Date: September 8, 2020
To: Planning Board
From: Kellie Walsh, Town Planner
Subject: **San-Ken Homes, Inc. (owner/applicant)** – Conceptual discussion for a potential site plan to construct a two condominium buildings totaling seven units along with associated site improvements. The parcel is located at an unnumbered parcel on Wheeler Street in the Residence A District, Floodplain Management and Wetland Conservation Overlay Districts. Tax Map 30, Lot 19.

**Re: Interdepartmental Review Map 30 Lot 19
Wheeler Street Condos**

COVER SHEET
CONDOMINIUM SITE PLAN
MAP 30, LOT 19
WHEELER STREET, MILFORD NH

LANDSCAPE LIGHTING PLAN
 CONDOMINIUM SITE PLAN
 MAP 30, LOT 19
 WHEELER STREET, MILFORD NH

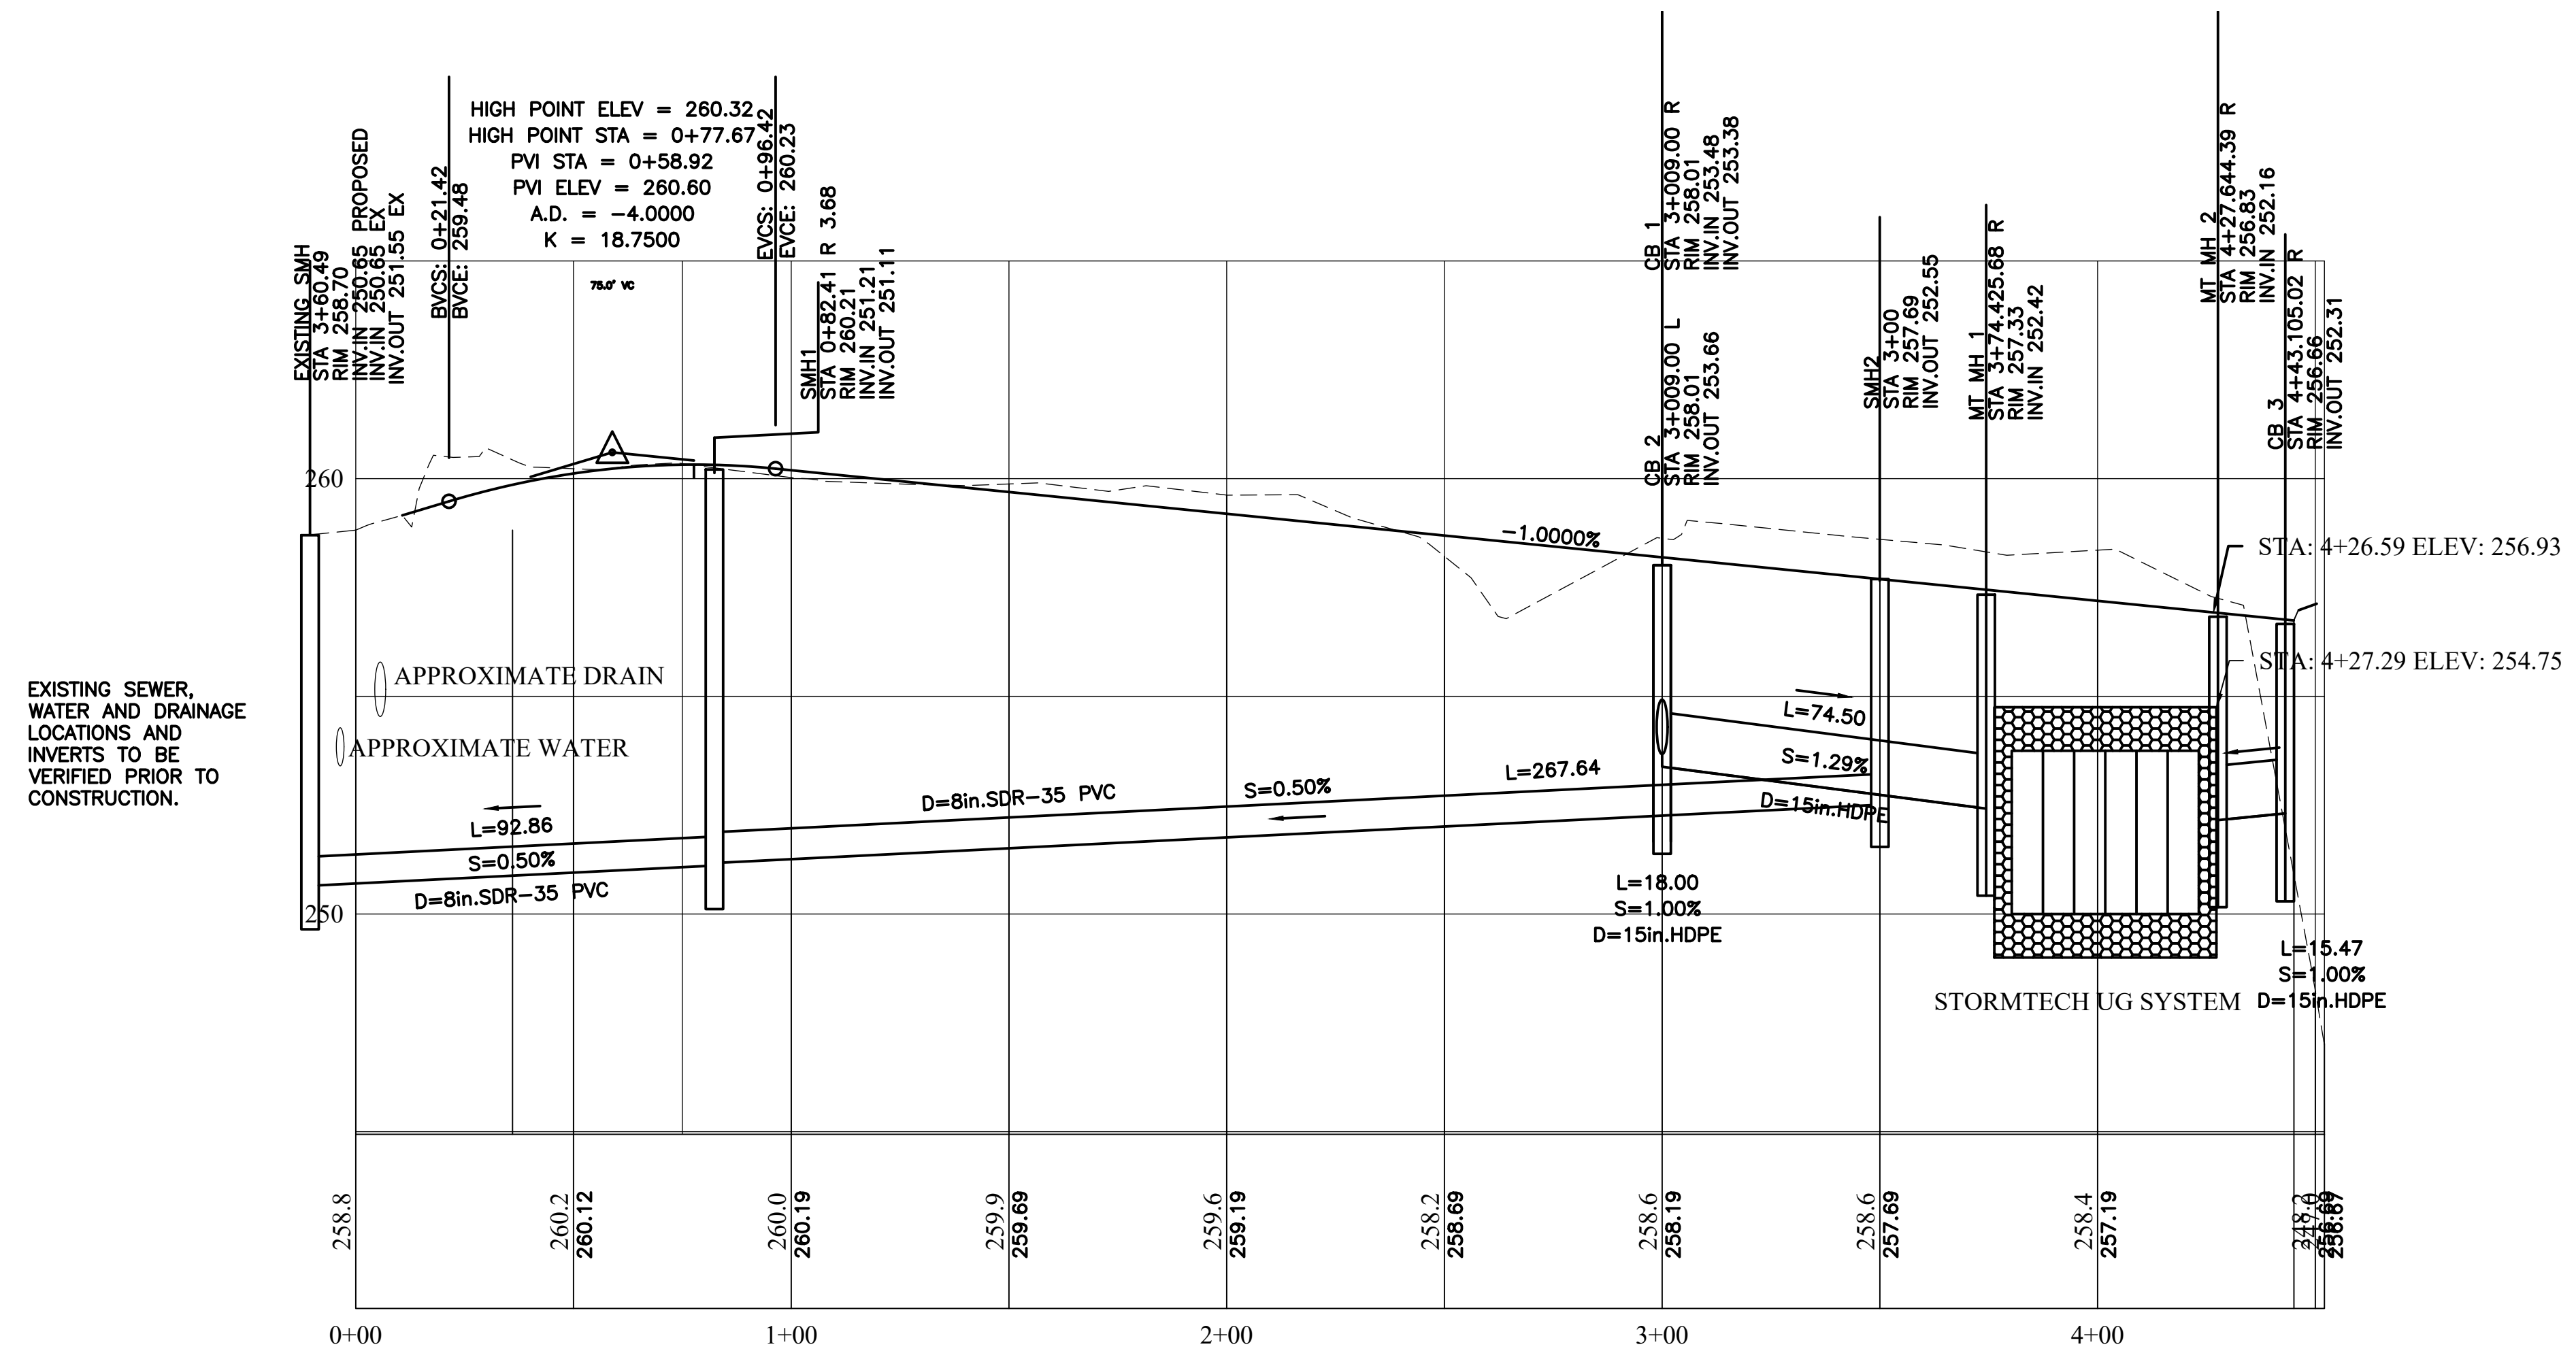
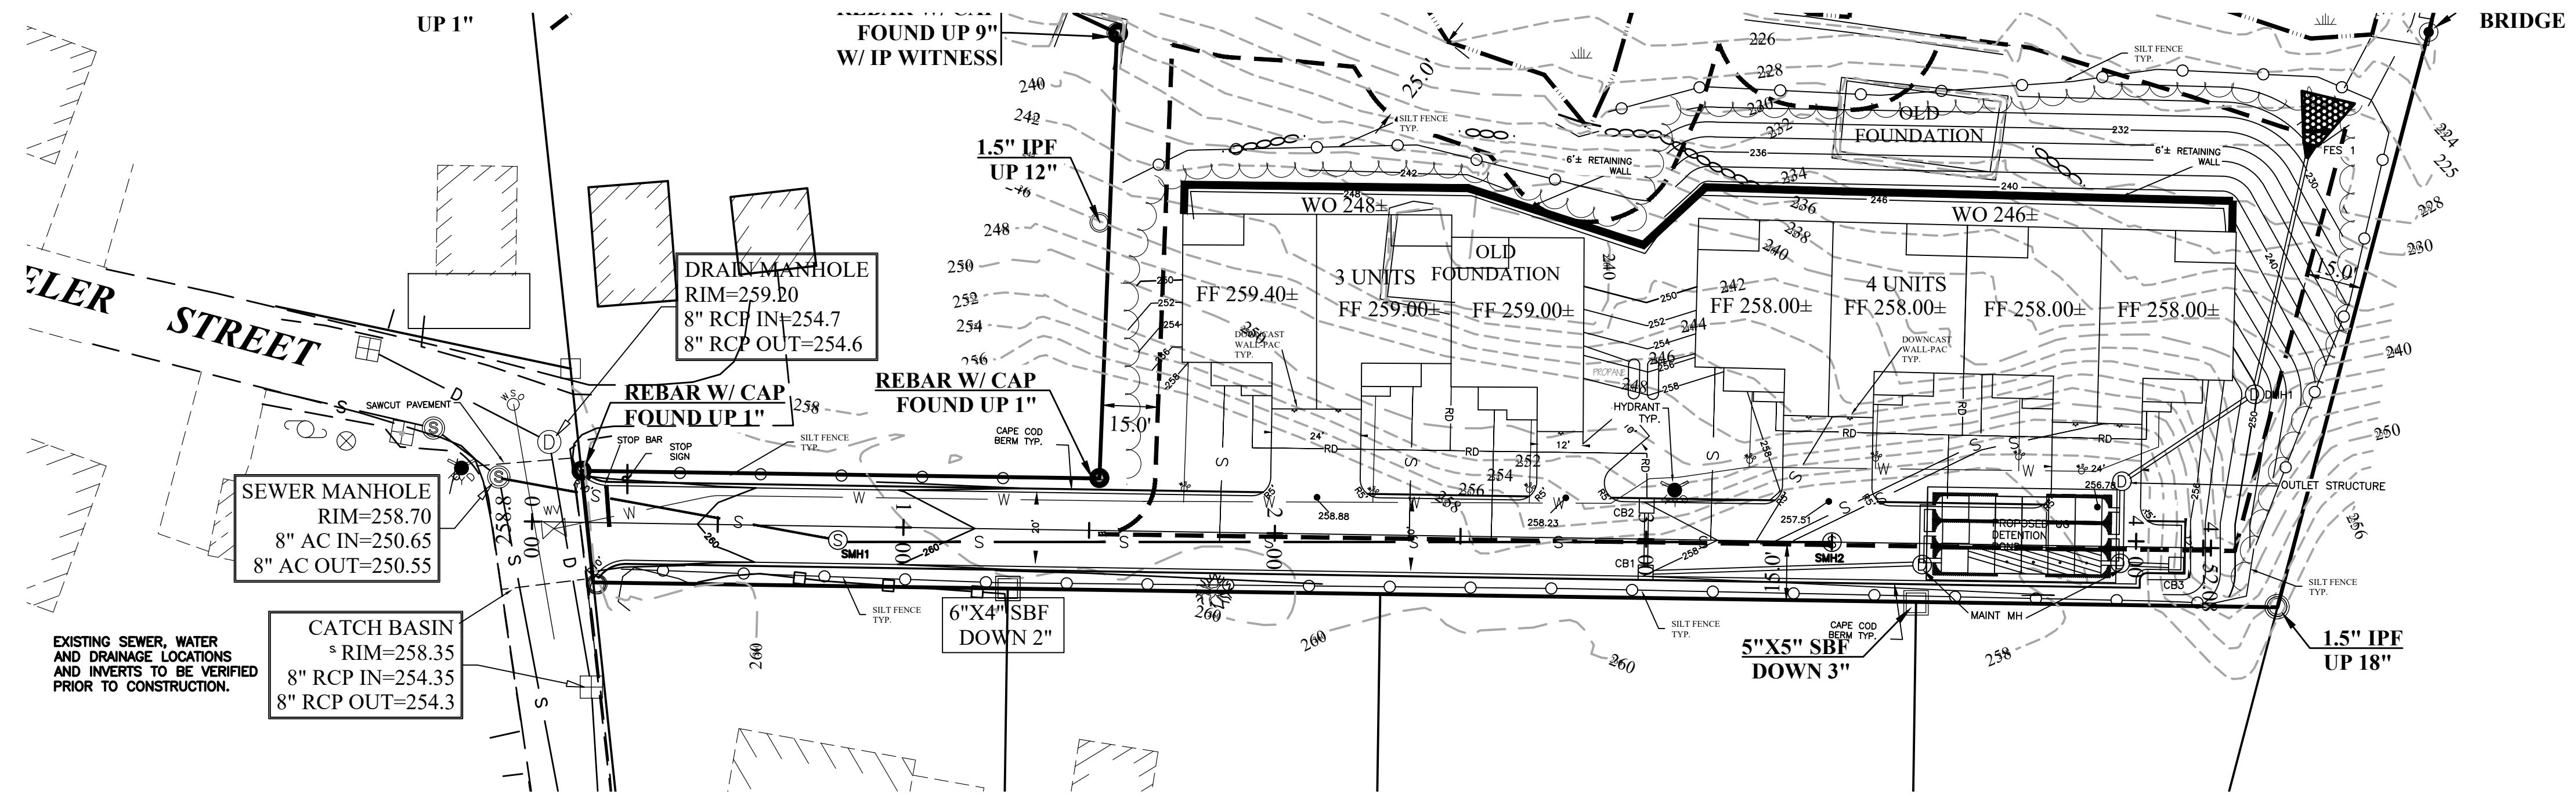
3. The snow storage area appears to be inadequate for this site.
4. Sheet 6 – Landscape and Lighting Plan indicates planting euonymus alatus (Burning Bush), which is a NH prohibited species. This plant needs to be removed from the landscape plan.
